**SUBJECT      Emergency Plan for the PULSTAR Nuclear Reactor,  
Revision 11  
License No. R-120  
Docket No. 50-297**

## **Review of Changes for Emergency Plan Revision 11**

# PULSTAR REACTOR EMERGENCY PLAN

**Figure 3 – North Carolina State University North Campus**

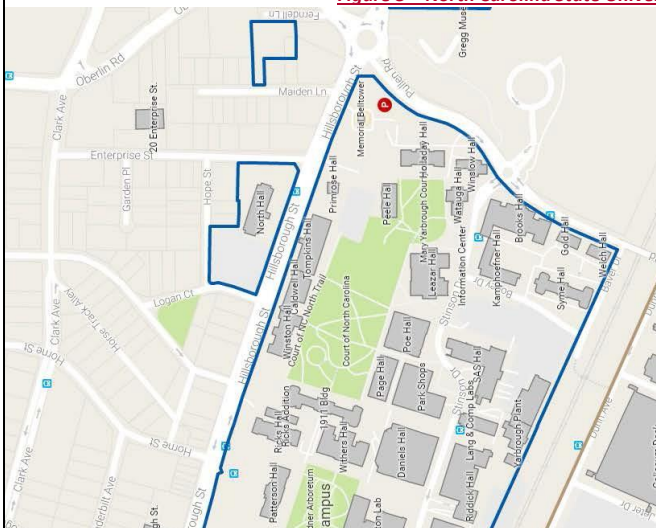
| Section  | Description of Change                                                                                                                                                                                                                                                                                              |
|----------|--------------------------------------------------------------------------------------------------------------------------------------------------------------------------------------------------------------------------------------------------------------------------------------------------------------------|
| Figure 3 | <p>NCSU renamed “Daniels Hall” to “111 Lampe Drive”. Figure 3 was updated with the correct name.</p> <p><i>Updated information on the map does not decrease the effectiveness of the emergency plan.</i></p>                                                                                                       |
